BR 42 MT. HOLLY MM 6.043 = STA. 9+725.266

**BRIDGE
DETAIL
SHEET #5**

SURVEYED BY	N/A	DATE	N/A
DRAWN BY	C.A.K.	DATE	
SQUAD LEADER	T.P.K.		
DESIGN FILE NO.	/pave/01b024/pb024.dgn		
IPARM FILE	pb024b05.d	DATE PLOTTED	\$DATE\$
PROJ. NAME	LUDLOW - MT. HOLLY		
PROJ. NO.	NH_2327(1)S		
SHEET	80	OF	84 SHEETS

BR 42 BRIDGE POST DETAIL

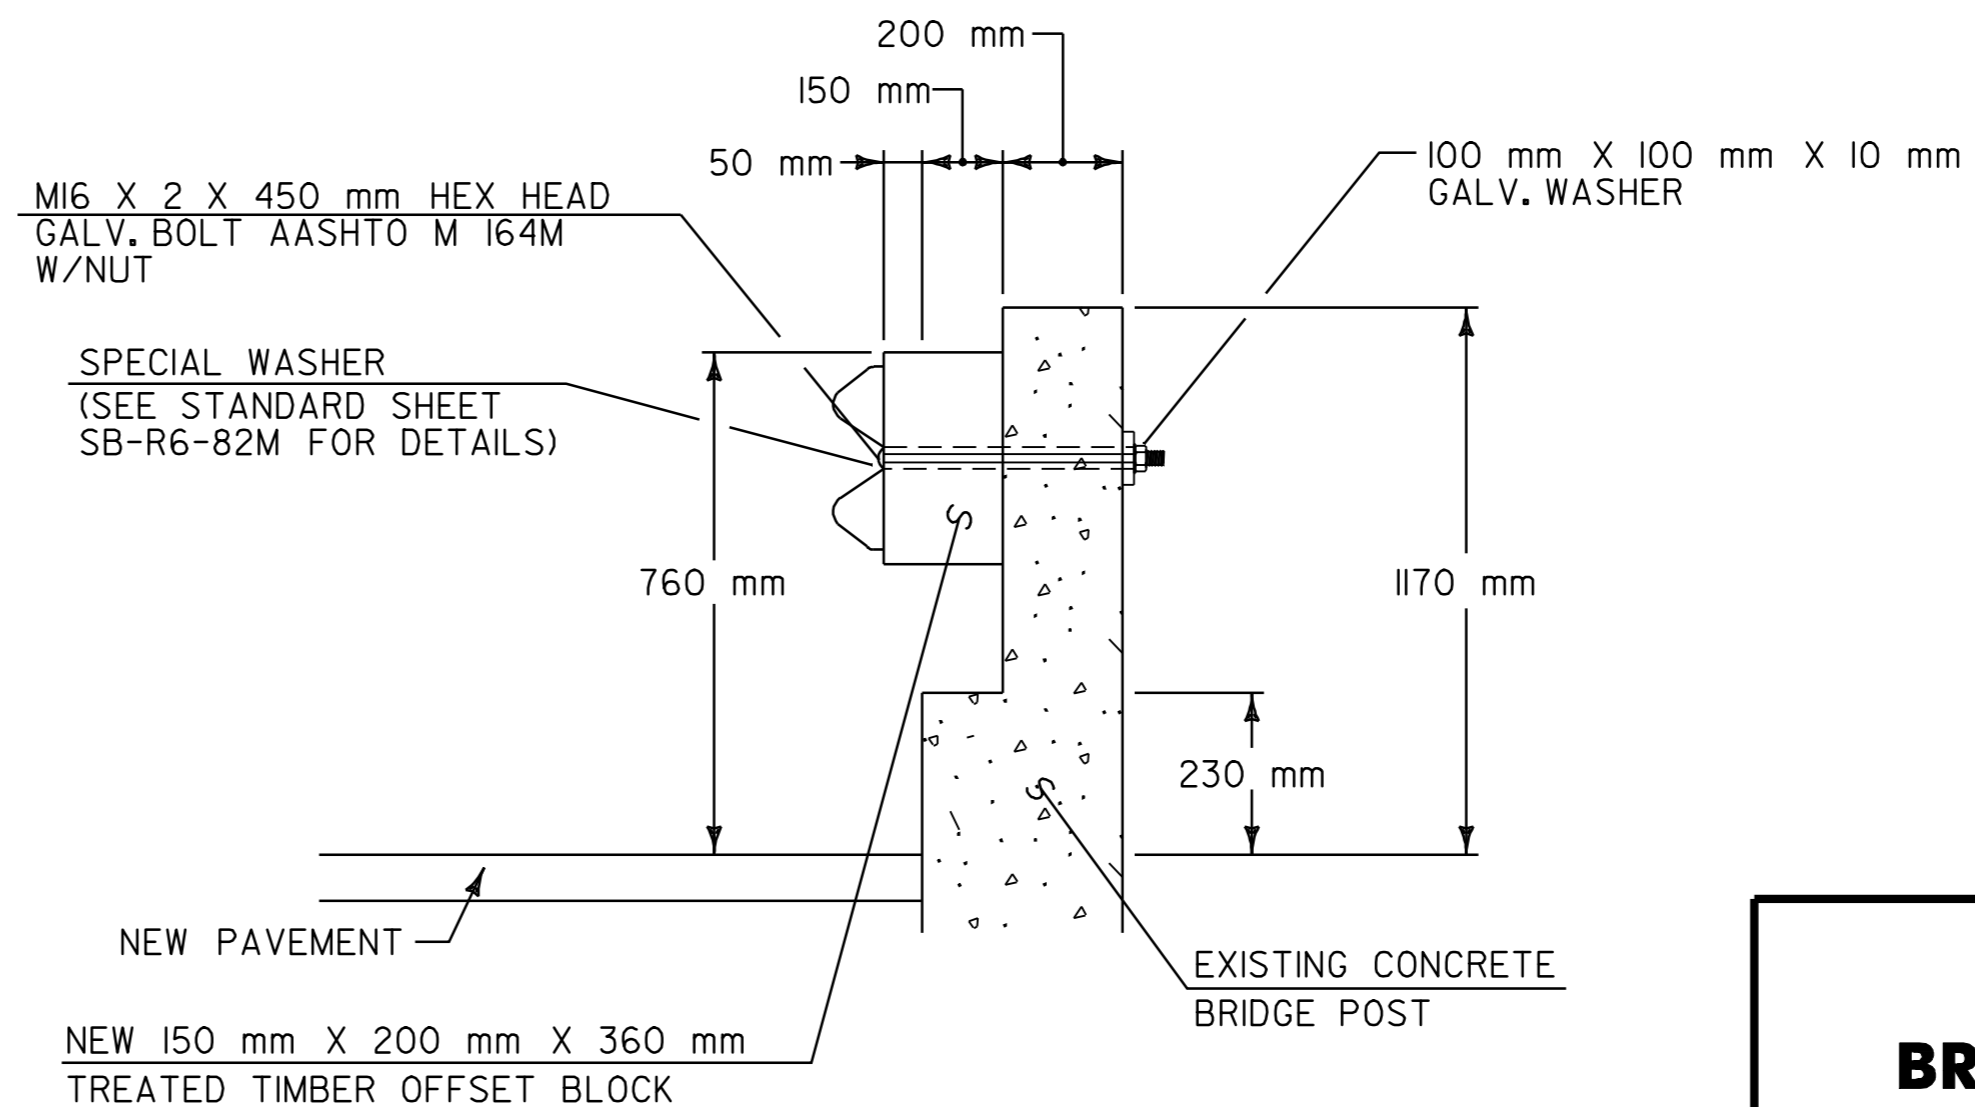
EXISTING STEEL OFFSET BLOCKS REINSTALLED
DUE TO ALIGNMENT PROBLEM W/ NEW TIMBER BLOCKS
